Addendum #6

Patton's Busy Bee Disposal Site

Site No. 902014

REVISED OPERATION AND MAINTENANCE MANUAL

Client: NYSDEC	Location: Patton's Busy Bee Disposal	Project No. 35703.02
URS Greiner, Inc.	MONITORING WELL CONSTRUCTION DETAILS	Well Number: MW-1071R

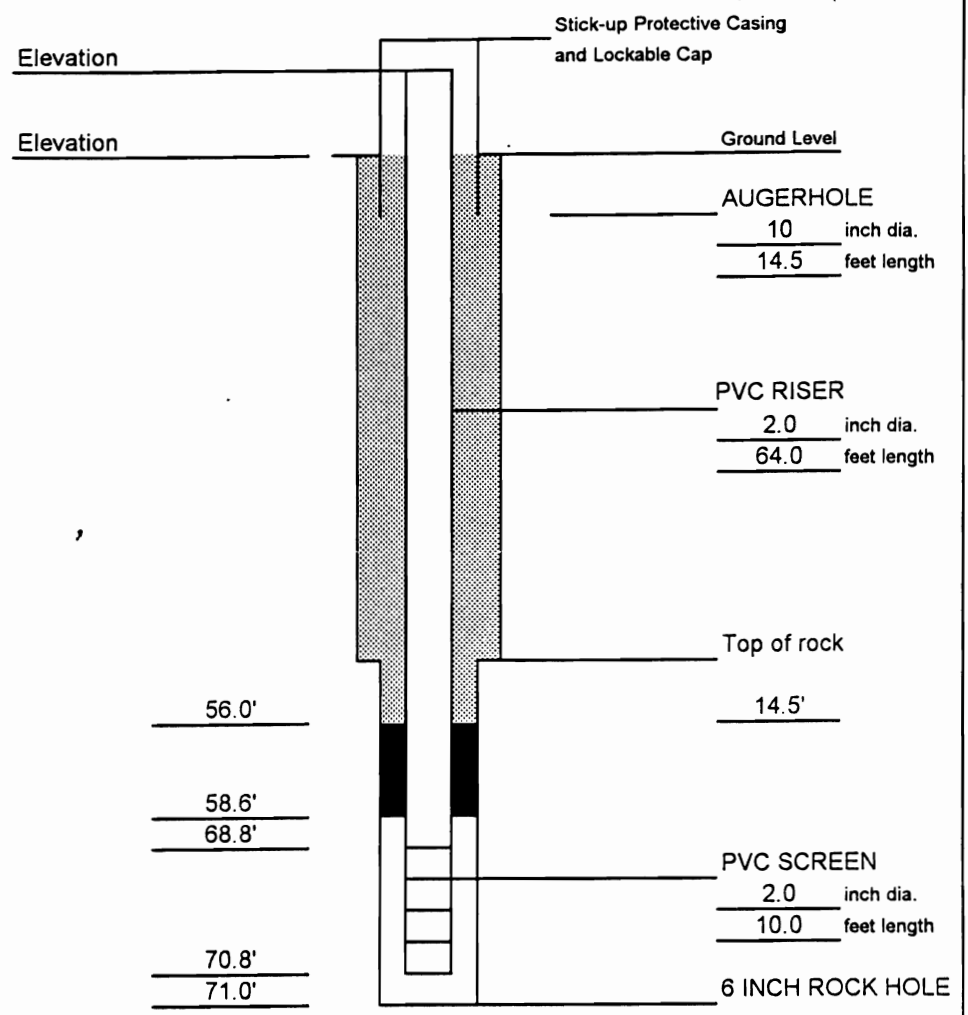
Site monitoring wells MW-107S and MW-107I were replaced in November 1999 with monitoring wells MW-107SR and MW-107IR. Refer to report dated 11/17/99 by URS Greiner Woodward Clyde Consultants for well construction details. Refer to Table 3 for list of Long Term Monitoring Wells.

Client: N.Y.S.D.E.C.	Monitoring Well Construction Details	Project No.: 0535352.00
URS Consultants, Inc.	Patton's Busy Bee Alfred Station Allegany County, NY	Well Number: MW-1011

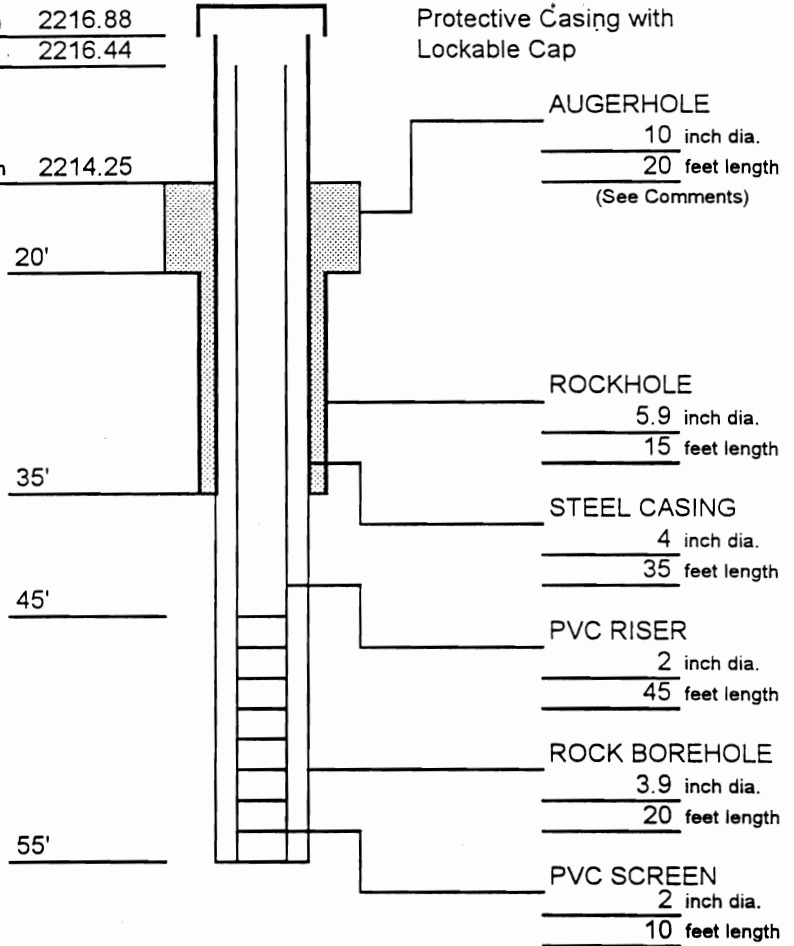
Four (4) additional monitoring wells will be added to the annual groundwater monitoring. These wells will be MW-101 I & D and MW-104 I & D. These wells will provide additional data on the groundwater quality to the north and west of the landfill. Existing 1" diameter MW-107 S & I will be decommissioned and replaced with 2" diameter monitoring wells and will be identified as MW-107SR and MW-107IR. Refer to revised Table 3 for list of Long-Term Monitoring Wells.
